PLANS

STATE OF NEW YORK
DEPARTMENT OF TRANSPORTATION
DESIGN AND CONSTRUCTION DIVISION
PLANS FOR CONSTRUCTING THE
EUCLID - NORTH SYRACUSE HIGHWAY

Field Change Sheets:
3F1, 5F1, 53F1, 12F1, 13F1, 13F2, 134F1, 135F1, 136F1, 137F1, 138F1, 139F1, 100F1, 101F1, 102F1, 103F1, 104F1, 105F1, 106F1, 108F1, 117F1, 119F1

As Built Revisions by Francis H. Backus
Approved: Eugene Parous, Asst. Contr. Supervisor, 3-27-1973
P.E. License No. 37013

Fed Rd REG NO	STATE	Federal Aid Project No	Sheet No	TOTAL SHEETS
1	NY		108G1	257
PHOENIX-SYRACUSE, S.H. 5274				
EUCLID-NORTH SYRACUSE, S.H.				
TRAFFIC SIGNS				
FIELD CHANGE

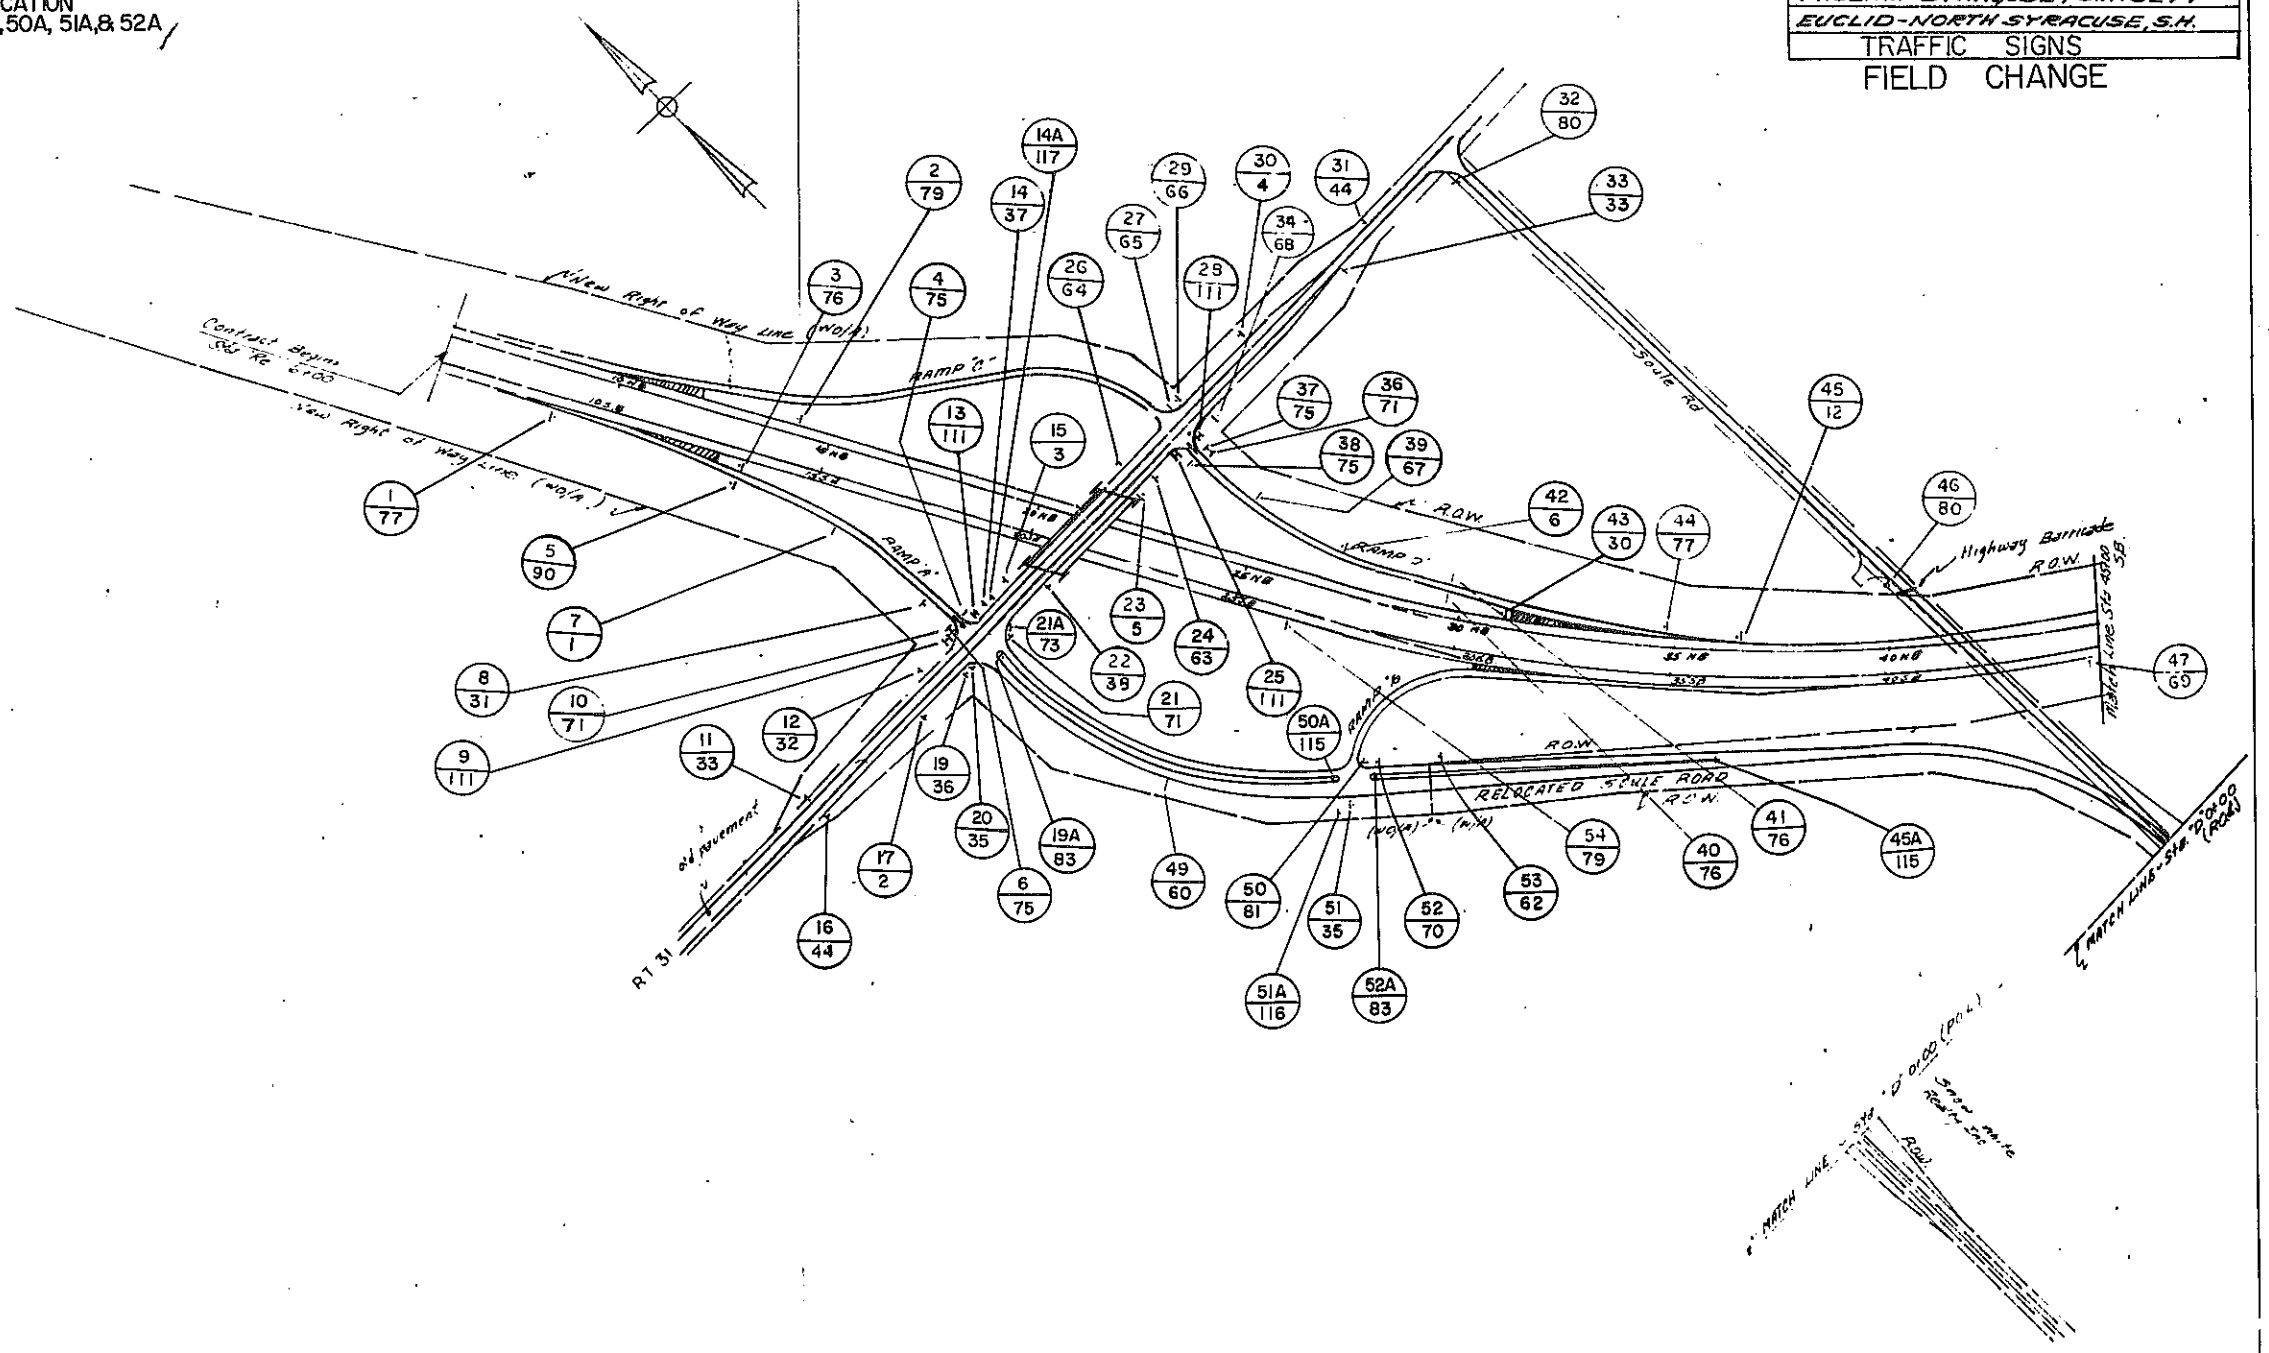
FIELD CHANGE
SHEET 108 G1 SUPERSEDES FIELD
CHANGE SHEET 108 F1 BY THE
ADDITION OF NEW SIGNS, LOCATION
NOS. 14A, 19A, 21A, 45A, 50A, 51A, & 52A

EUCLID-NORTH SYRACUSE, S.H.
MATTYDALE-BREWERTON, S.H. 57-6
SYRACUSE-CICERO, S.H. 5710

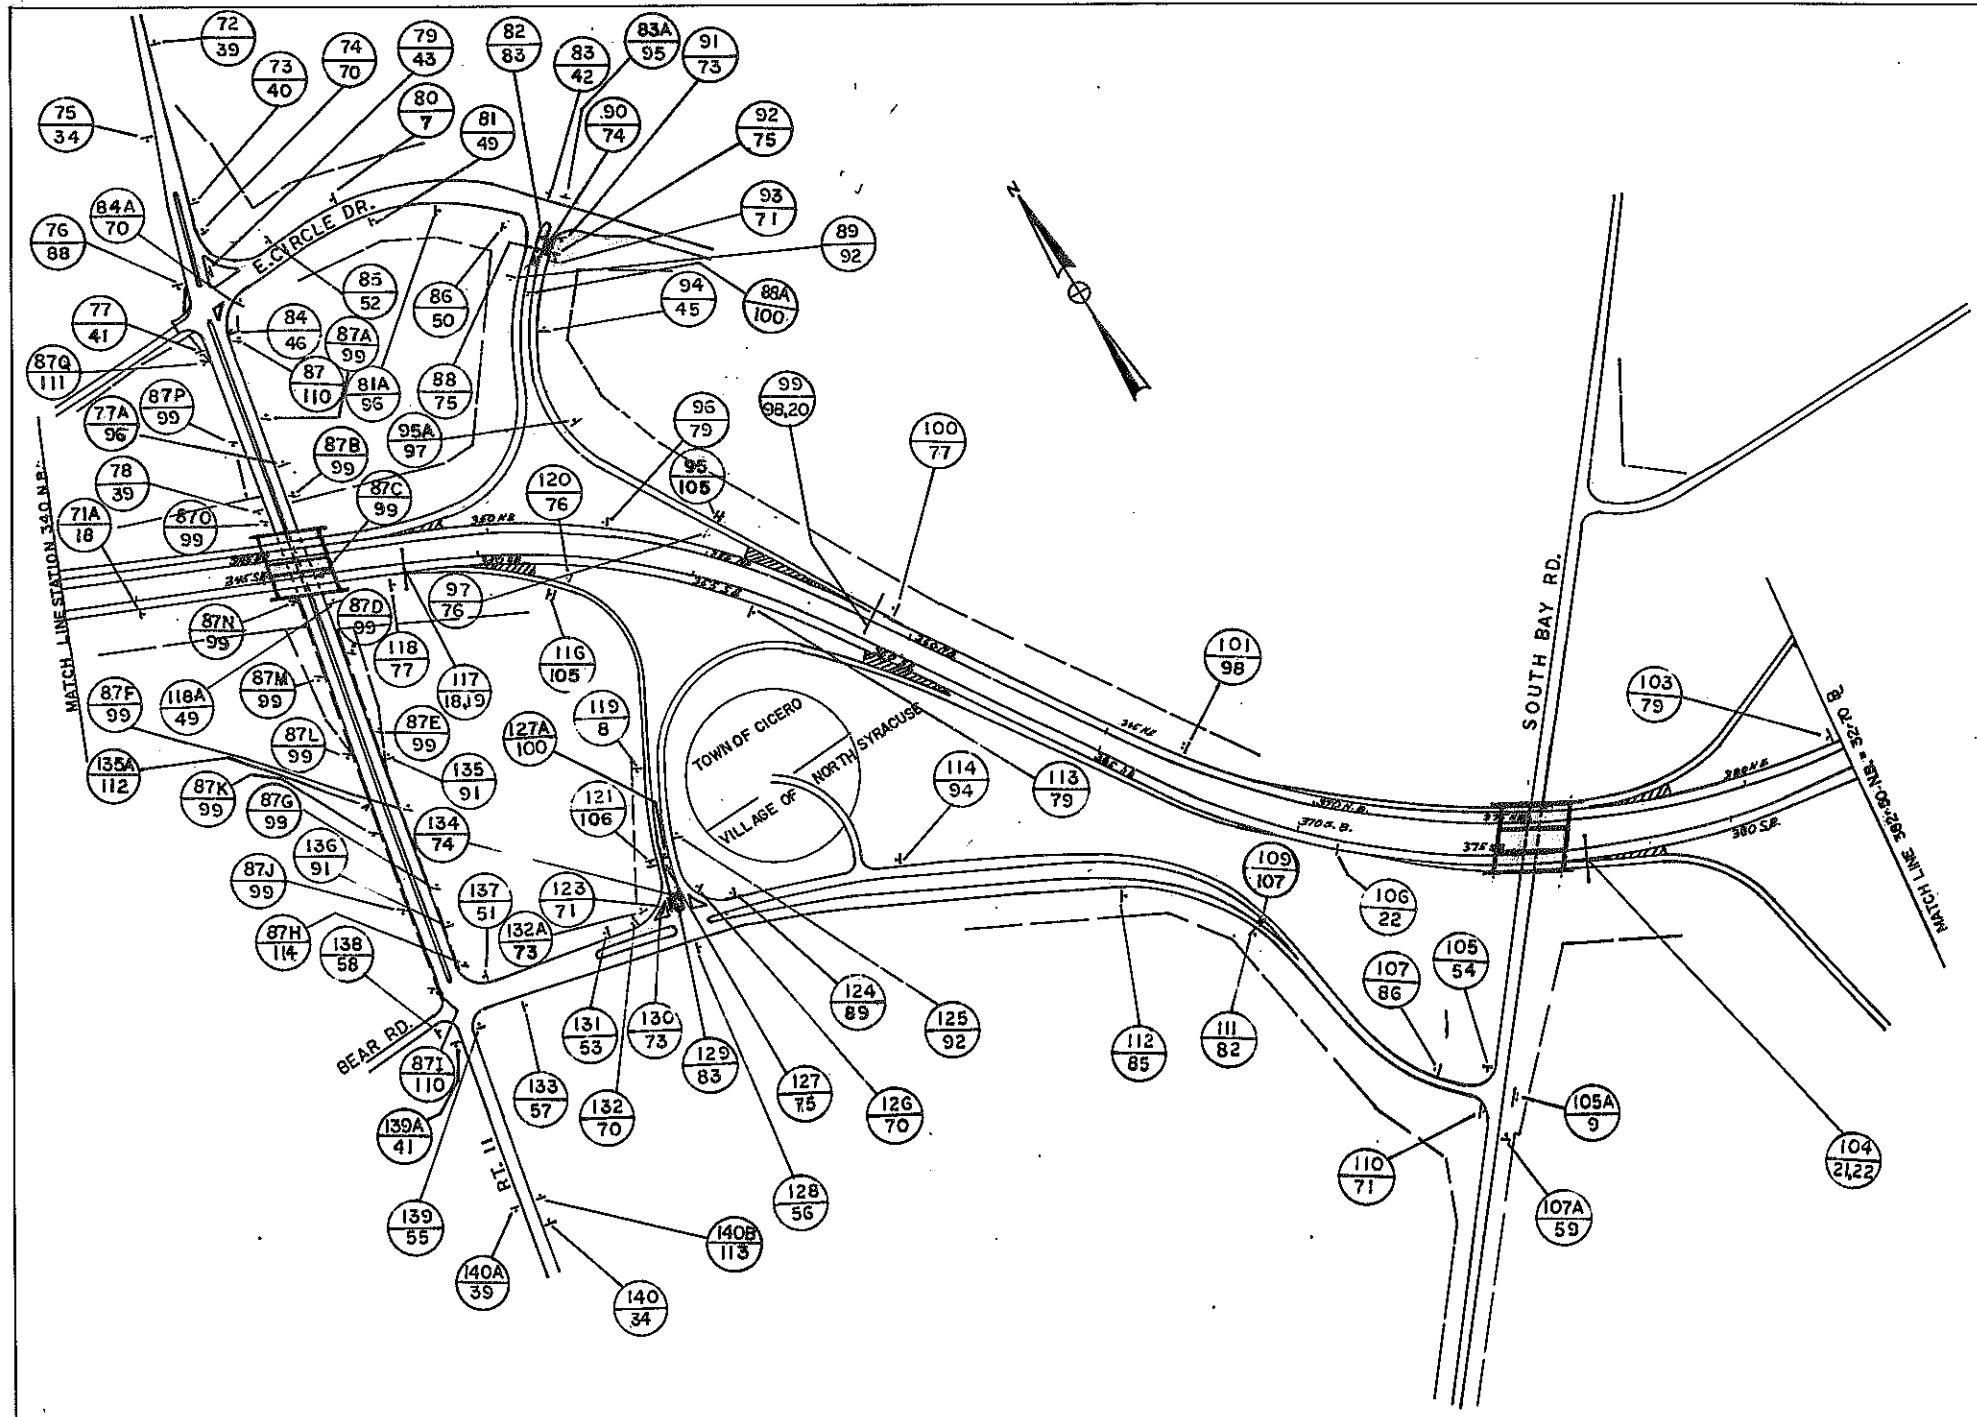
FOR CONTRACT NO. SH 69-5, RC 69-102.
PROJECT IDENTIFICATION NO. 3035.00.
SHEET 114F1 MODS ALL OF ORIGINAL SHEET
114 BY THE ADDITION OF SIGNS, VICINITY OF
E. CIRCLE DRIVE.

FED. ROAD REG. NO.	STATE	FED. AID PROJECT NO.	SHEET NO.	TOTAL SHEETS
1	N.Y.		135	257

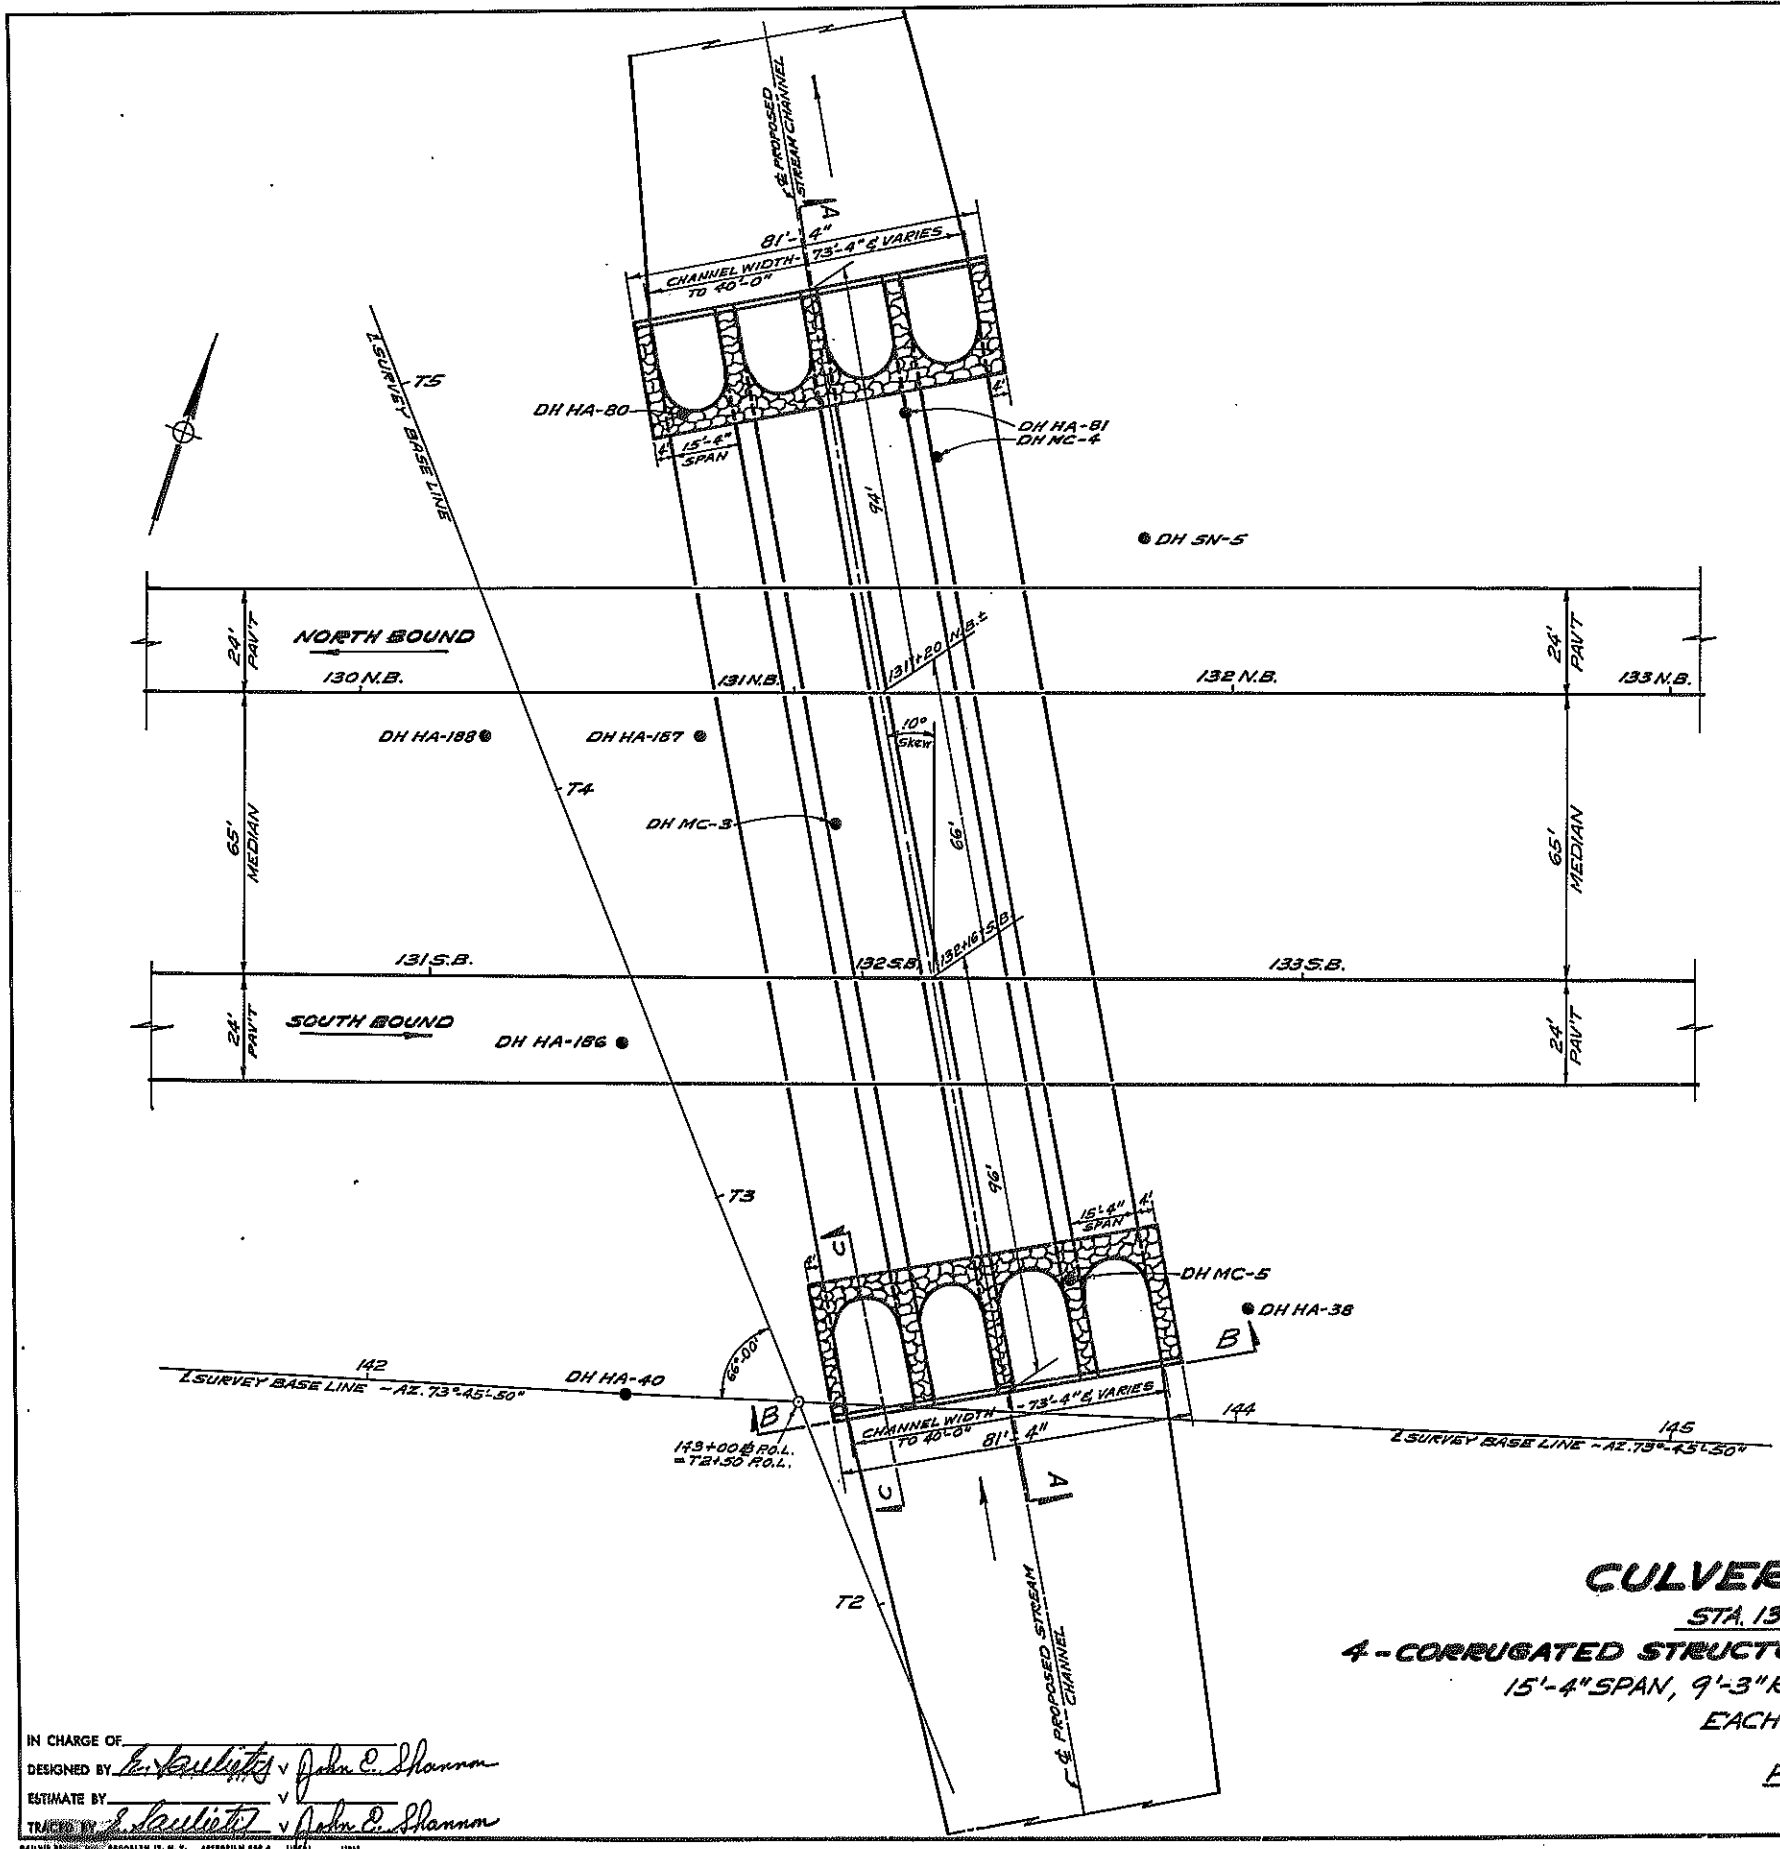
FIELD CHANGE SHEET
 FOR CONTRACT NO. S.H. 69-5
 CAPITAL PROJECT IDENTIFICATION NO. 3035.00
 SHEET 135F1 VOIDS ONLY PART OF ORIGINAL SHEET 135.
 THIS CHANGE INVOLVES THE ALTERING THE BEVEL ON THE ENDS OF THE PIPE FROM A 1 ON 4 TO A 1 ON 2 SLOPE.
